ENGINE - HP COMPRESSOR - INTRODUCTION OF 12 SPACERS ON THE REAR PISTON RING SEAL -
CATEGORY CODE 6 - MOD.ENG-72-0038

V2500-ENG-72-0038

SERVICE BULLETIN

View showing bolt and spacer on rear piston ring seal - After alteration
Fig.1

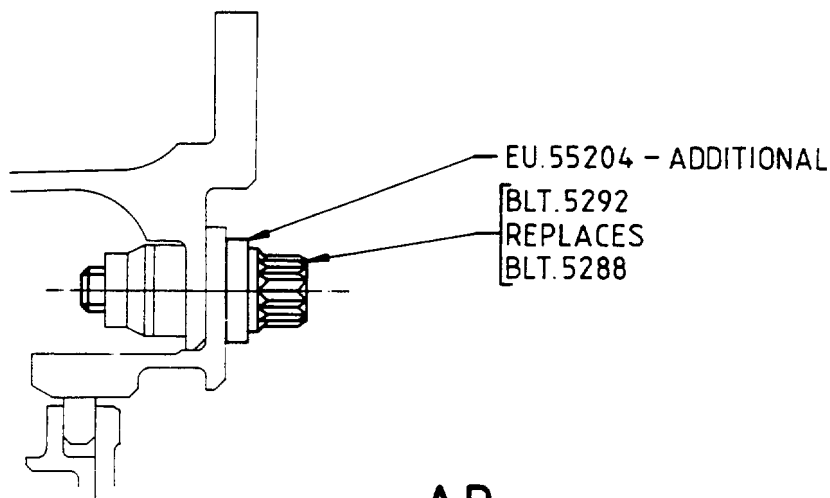
- (a) Twelve spacers are introduced at the twelve bolt positions on the rear piston ring seal where previously no spacers were utilized.
- (b) The twelve existing bolts have been deleted and are now common with the existing sixty longer bolts to accommodate the extra clamped thickness.

The new EU55204 spacers and additional BLT 5292 bolts introduced by this Service Bulletin are interchangeable with in use spacers and bolts. Assemble by use of approved procedures, Engine Manual, 72-41-00, Assembly.
